# OFFICER'S RESPONSE TO DIRECTIONS FROM THE HEARINGS PANEL

HEARING: Variation 1, Hearing 8 - ISPP - Rezone Lincoln

PREPARED BY: Vicki Barker, Consultant Planner

# Manmeet Singh - ODP9

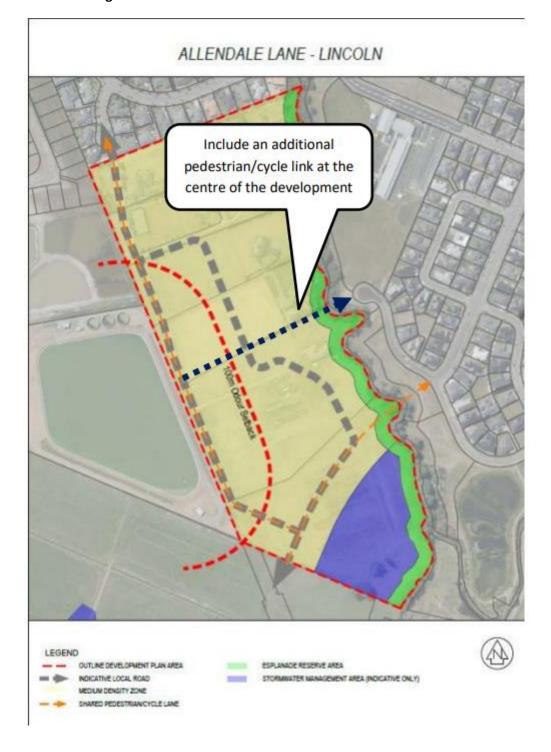
Based on this advice, a mid-block pedestrian/cycle connection is recommended to be shown on the ODP in addition to the southern pedestrian/cycle connection shown on the ODP, and an amended ODP with this additional link shown is included in **Appendix 1**.

- (iii) Amend the ODP to show a mid-site pedestrian and cycle link to Jimmy Adams Terrace as originally proposed by the submitter and amend the ODP narrative accordingly;
